GATEWAY PORTABLES & SHADE STRUCTURES

Bid Clarification 01

September 21, 2026

DSA Application Number: 01-122796

G-0.4

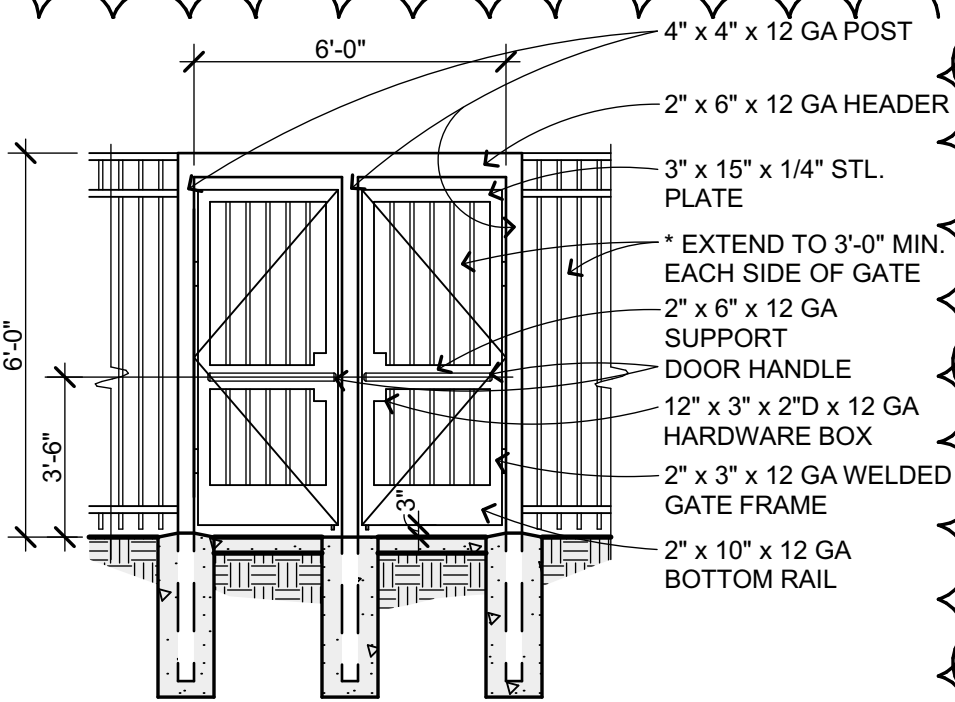
Item No. 1. 02 G-0.4 Access Site Plan
Replace G-0.4 with the attached G-0.4.

DOOR SCHEDULE & GATE DETAILS

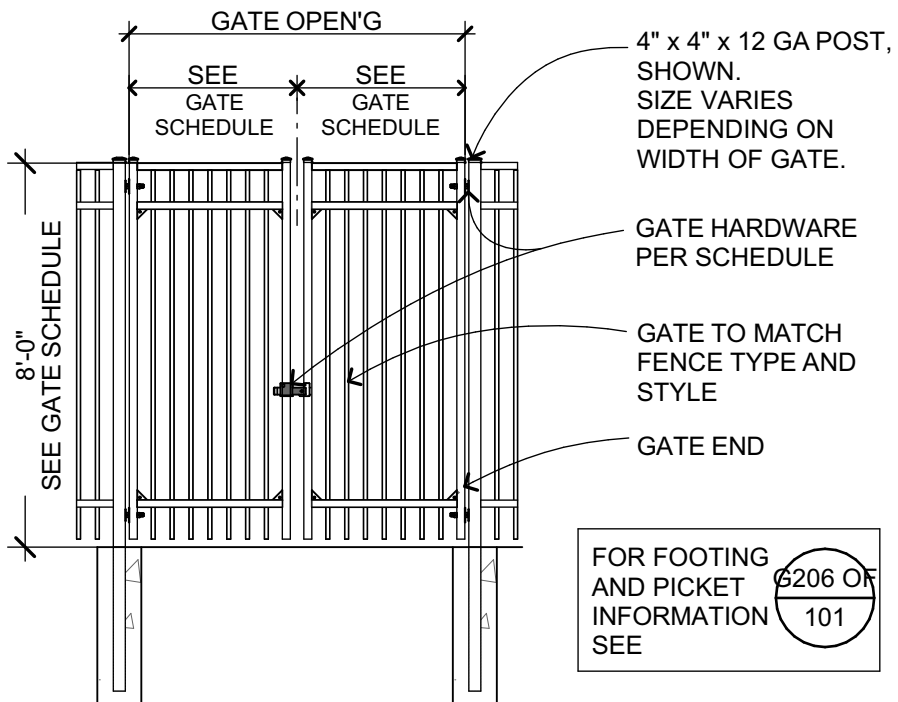
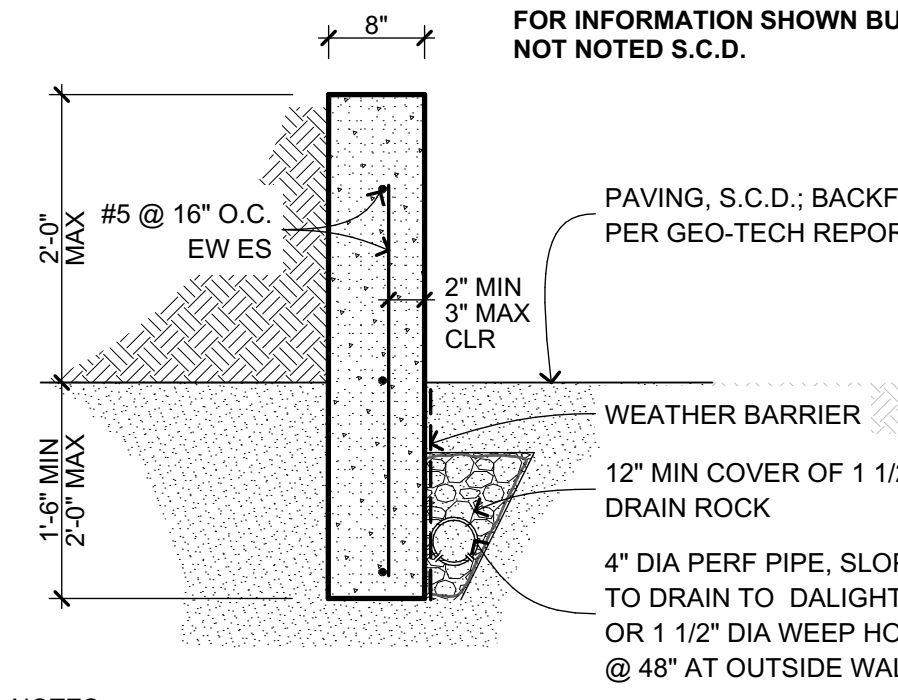
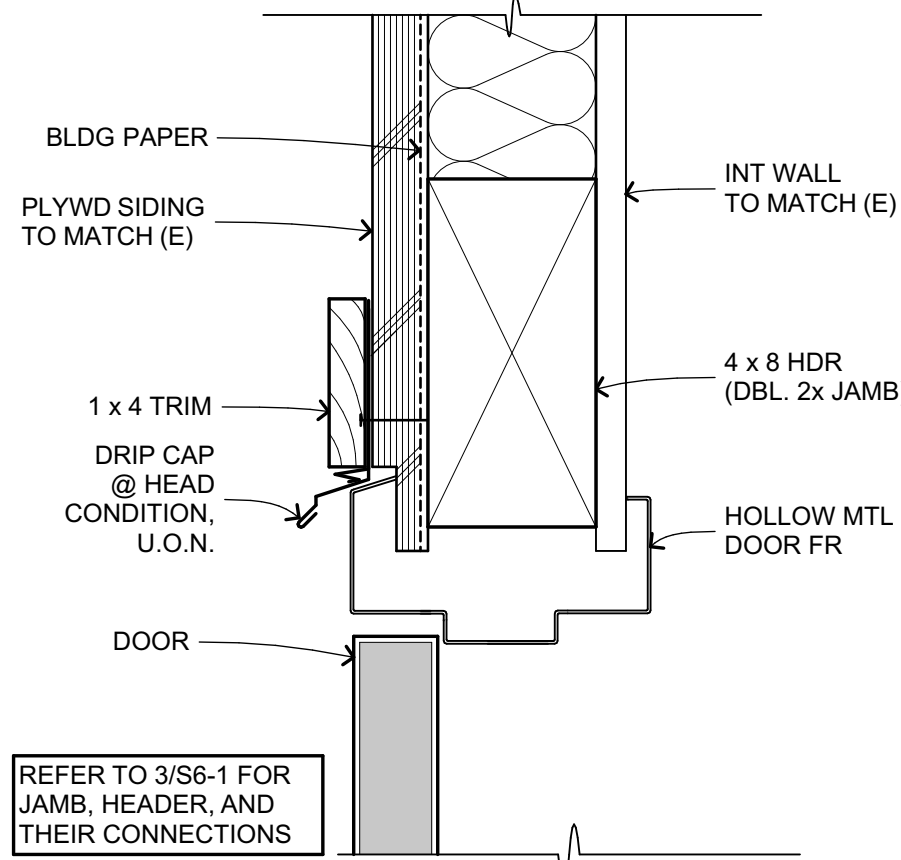
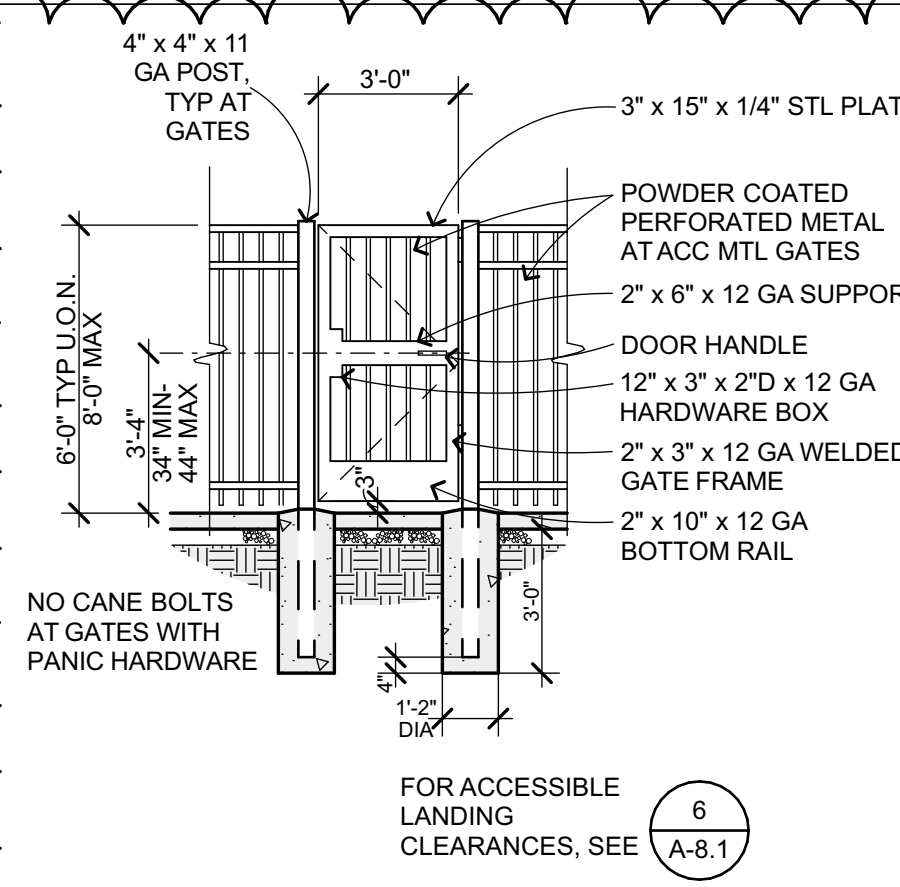
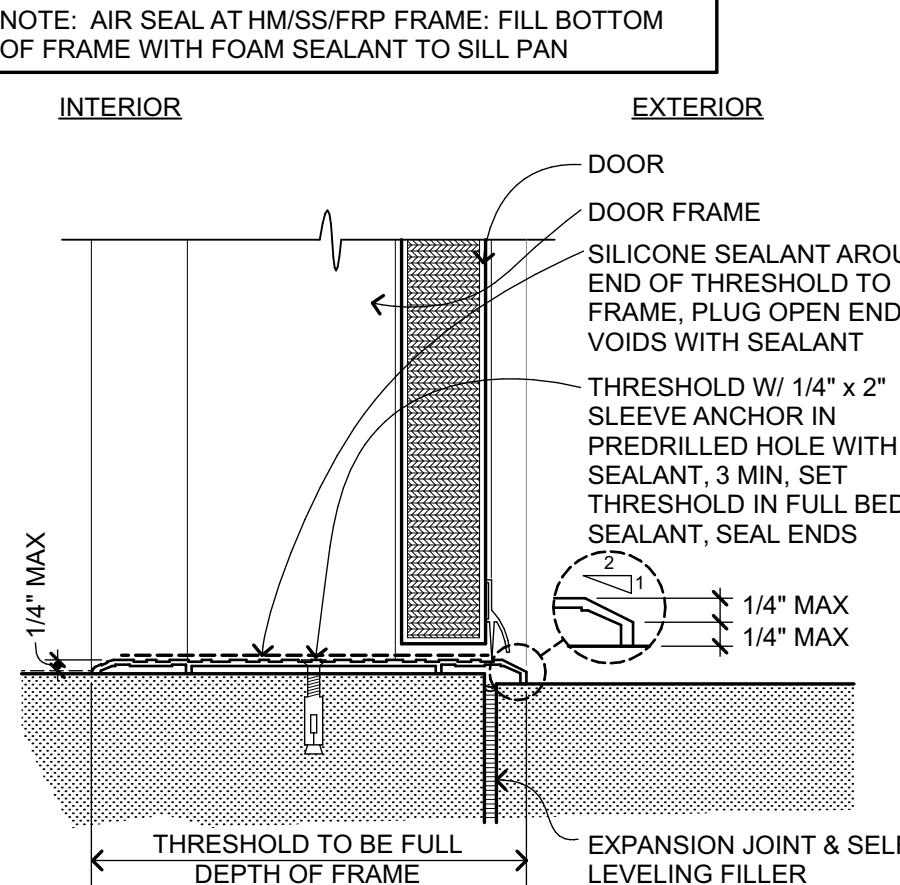
- Removed Chain Link Fence and Gate details
- Added Ornamental gate Details.
- Added concrete planter details.
